**Re: Geiger Hill
(Griffiss Business and Tech Park –
Proposed Commercial Development)
Response to Comments**

On behalf of Indus Hospitality Group (“Indus”), we have reviewed your staff review comments for the above-referenced project dated April 2, 2026. On behalf of the developer, we offer the following responses for the City’s consideration:

LANDSCAPE PLAN

ELEVATIONS
NEW PLAZA BUILDING for:
INDUS DEVELOPMENT
GEIGER ROAD
ROME NEW YORK

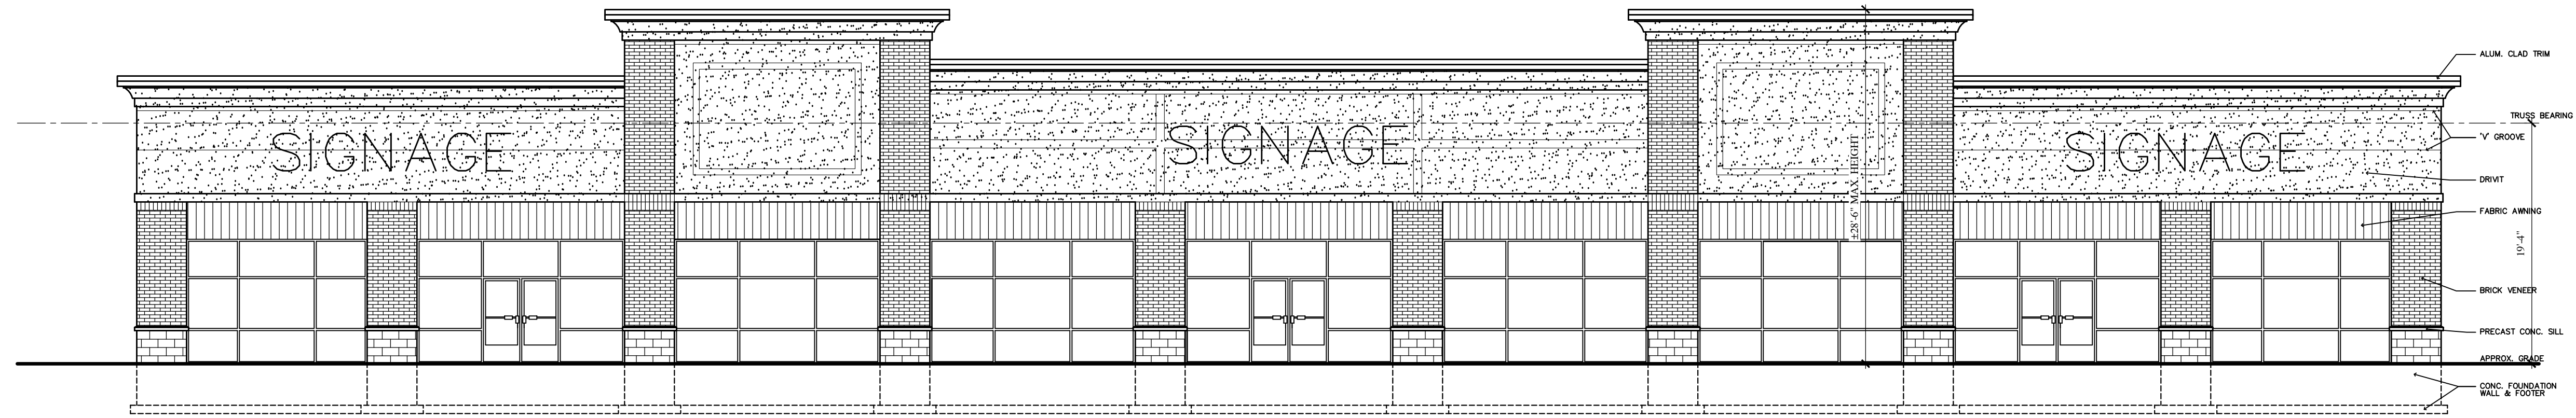
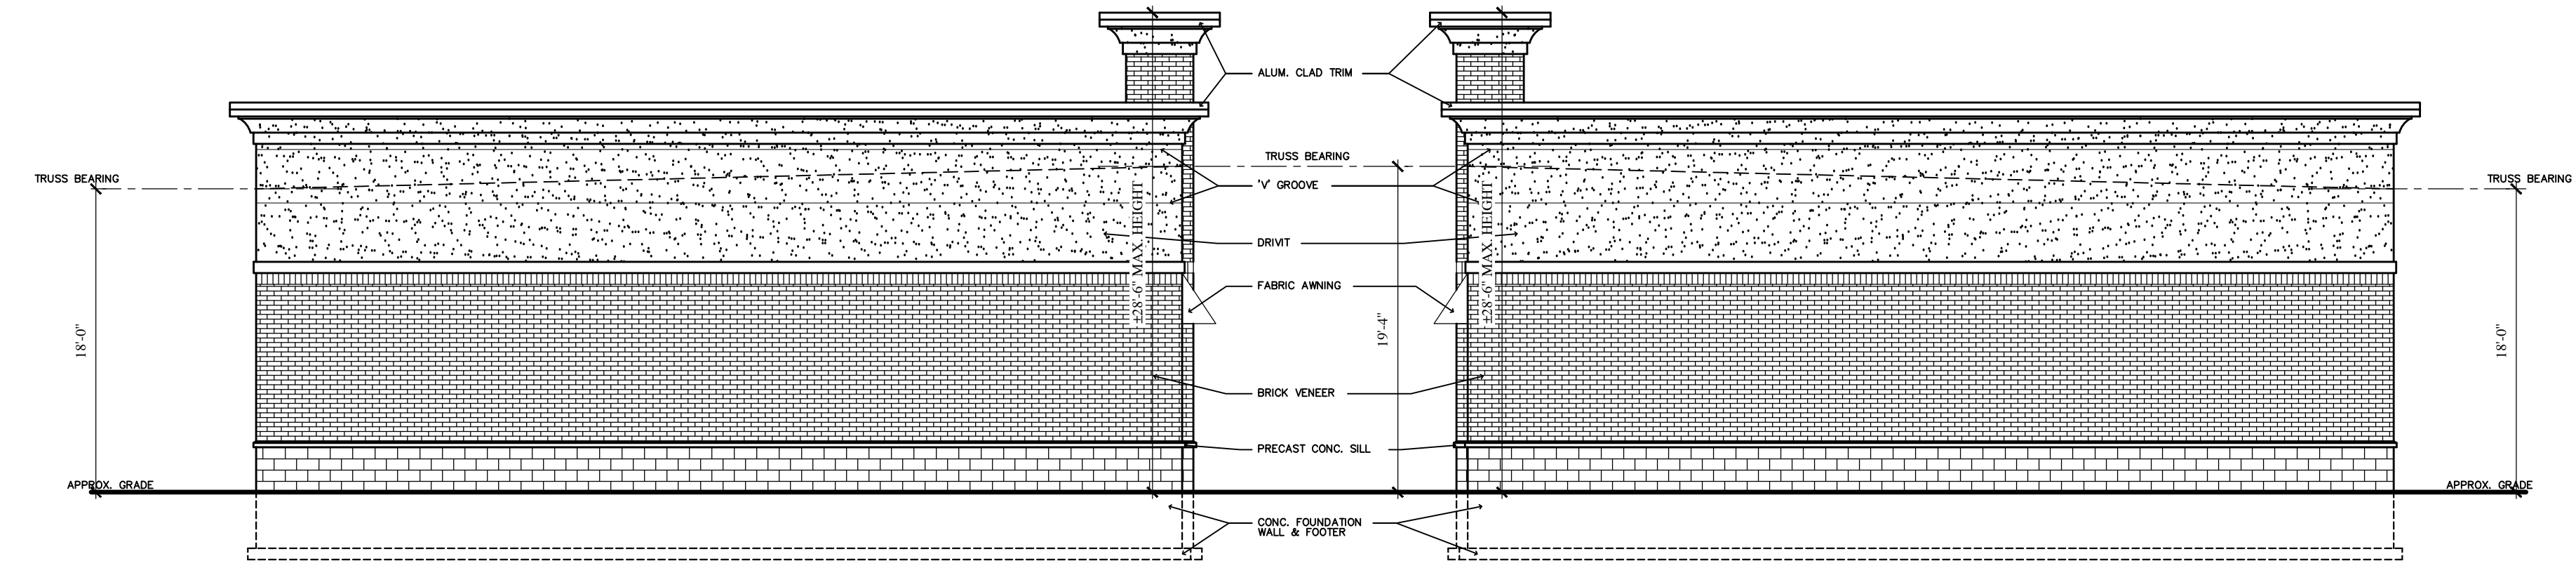
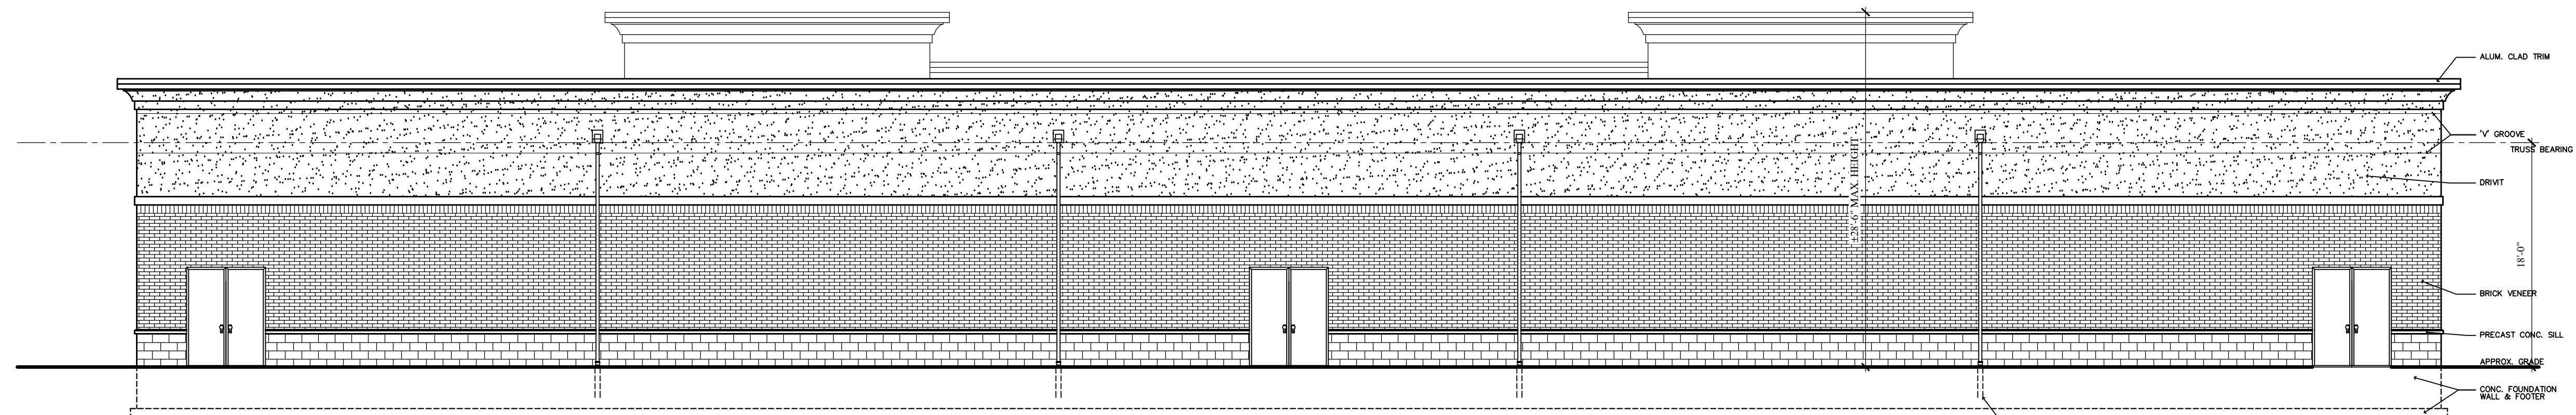
3. Please include to-scale architectural elevations for all proposed buildings and confirm that they comply with the design requirements laid out in Section 80-11.4 of the Zoning Code.

Updated architectural elevations of all proposed buildings are enclosed for the City’s review. As mentioned above, the signage is per the hotel brand’s prototypical design.
